ADDENDUM NO. 1

DATE: January 24, 2024
FROM: City of Grand Junction Purchasing Division
TO: All Offerors
RE: Recycling Materials Conveyors IFB-5368-24-KH

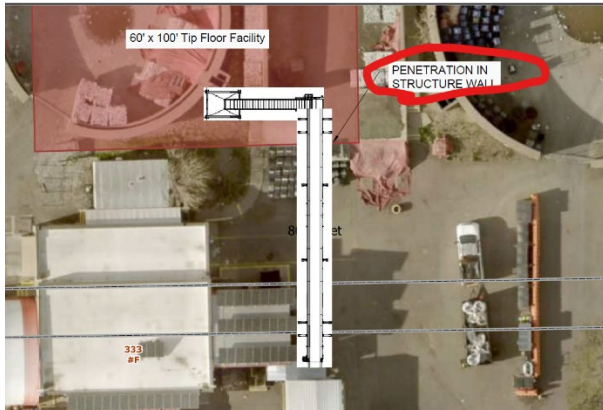
5. **Q:** Is the conveyor integrator responsible for the construction related to the "Penetration in Structure Wall" shown in the conveyor Belt Layout attachment, or has/will this occur outside of this bid? (See picture on next page)

A: The penetration will be "constructed by others" prior to the installation of the belt. Essentially, the building will be fabricated with a 4'x4' opening.
